CITY OF SMYRNA

MEMORANDUM

RE: REZONING CASE Z22-005– 2855 Spring Hill Parkway & 2685 Spring Road

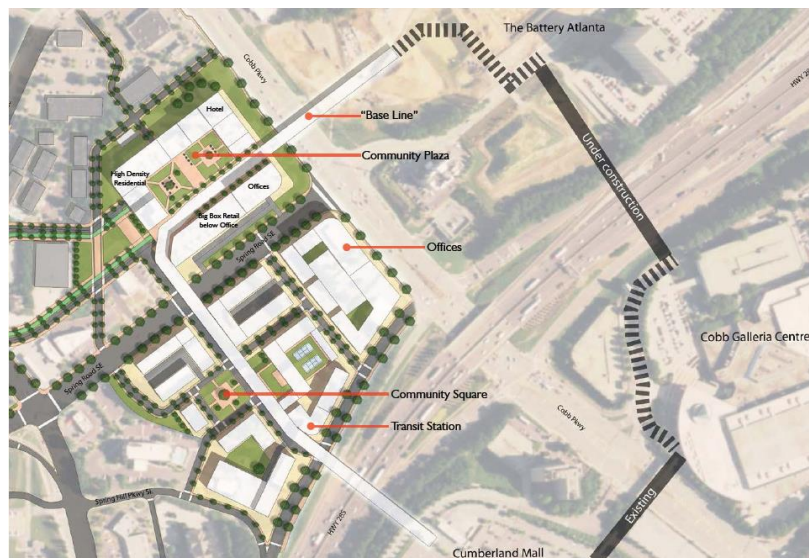
The City's Fire Marshal's Office has reviewed the proposed plan and believes that the Department will be able to serve the zoning proposal provided that it meets the City & State Fire Codes. The Fire Marshal's Office has provide the following items that need to be addressed with respect to the site plan to provide appropriate emergency response and access:

1. The applicant shall provide a full turning model for fire truck access with the specifications of the City's largest truck;
2. All radii within the development shall be a minimum of 25';
3. The site will be required to meet ADA requirements for access and parking; and
4. The building will be required to have a fire sprinkler system.

This development will need to address all the issues described above and meet all the city requirements with regards to the fire code.
